TECHNICAL BULLETIN

#1 | March 2016

SureFit[™] 2 Sprockets

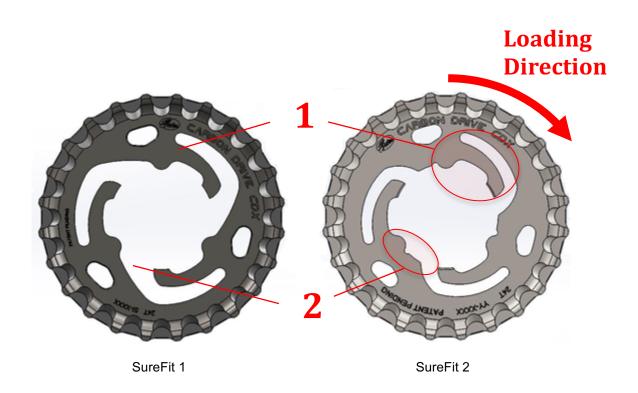
Gates Carbon Drive[™] introduces the new SureFit 2 sprocket design. This new design functions the same way as the original SureFit design, which uses flexible fingers to adjust to tolerance differences in hub drivers. However, it adds additional support to the sprocket, and reduces the stresses on the SureFit fingers.

- 1. SureFit finger reshape: New design better supports the load through the fingers.
- 2. Improved Concentric Controller: New design adds static support to sprocket, while maintaining normal fit and tolerance range.

Note: SureFit 2 calls out a specific loading direction for optimum sprocket life. Please note direction of rotation when mounting sprockets. On standard applications this means label side out.
